IMMINGHAM EASTERN RO-RO TERMINAL DCO APPLICATION

PINS REFERENCE TR030007

SUMMARY OF CASE MADE AT ISH1 BY DFDS

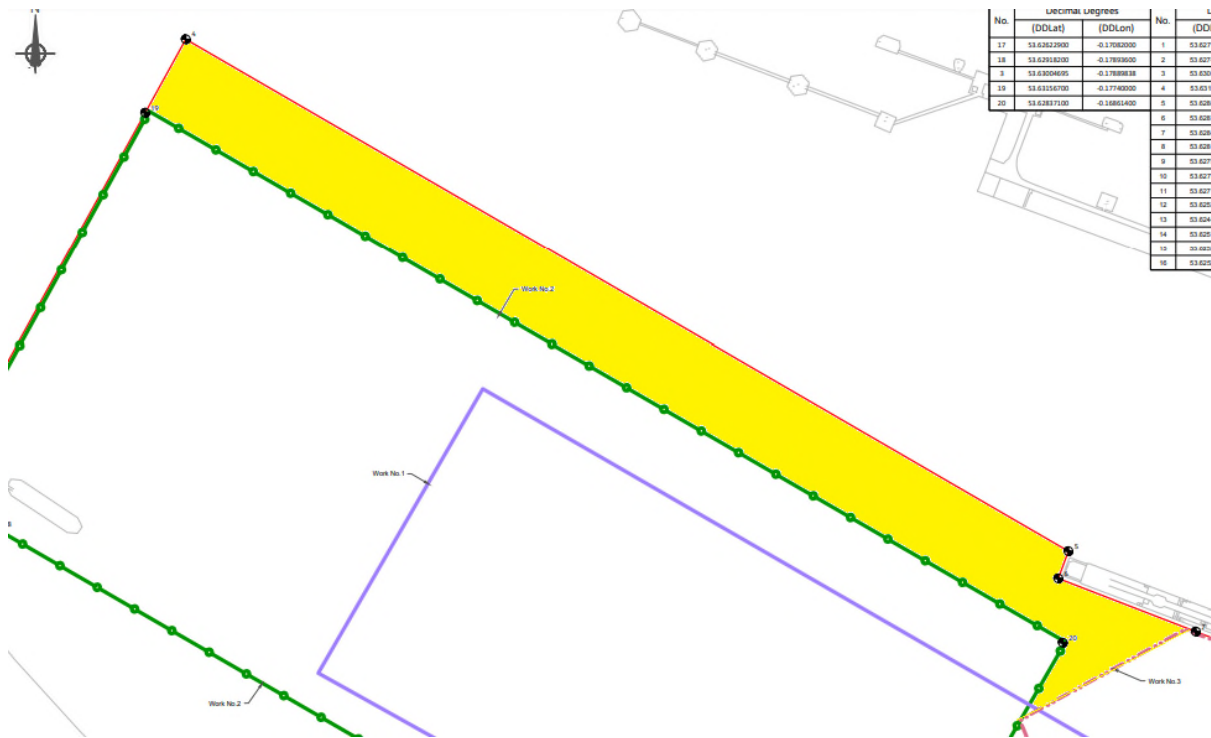
5. In relation to the definition of 'Order limits' the Works Plans do not set out the limits of construction activity as mentioned in the definition, and *DFDS question why the Order limits go beyond the limits of each work and what development is contemplated in such an area. For example, in this extract of sheet 1 of the Works Plans [APP-007], there is a seaward area beyond the limits of deviation of the works (the yellow area, the colouring has been added):*
